# **PITTS** AVIATION ENTERPRISES, Inc.

## SERVICE BULLETIN NO. 5

This Bulletin may be applicable to any Model S-2A airplane from serial number 2001 through 2025. (See paragraph 4. )

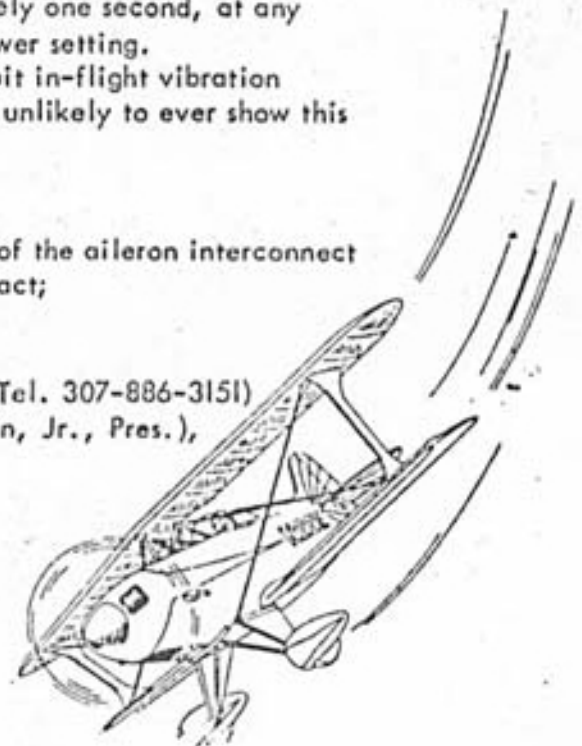
- If your aircraft has ever exhibited in-flight vibration of the aileron interconnect tubes exceeding one second continuous duration, contact;

and arrange for immediate shipment of two replacement aileron interconnect tubes, part no. 2-5216-11, (3/4 x .035 round tube, 4130 'N'). Send the original tubes to Aerotek, Inc. Note: If your airplane has exhibited the above noted in-flight vibration, it is recommended that you do not fly until installation of the replacement tubes is accomplished.

- b) When installing the replacement tubes, make certain to adjust the length at the lower threaded end to the same overall length between AN3 bolt centers as the tubes originally installed on your airplane. Also note that the same installation hardware at the upper and lower ends of the tubes may be retained for re-use, but make certain that the correct number of AN960-10 (1/16 or 1/32 thick) washers are installed so that the bearing inner races are clamped-up snugly without bending the fork ends of the tubes.
- c) Whether or not your airplane has exhibited the adverse vibration of the aileron interconnect tubes noted in this Bulletin, please execute the enclosed compliance card and mail to:
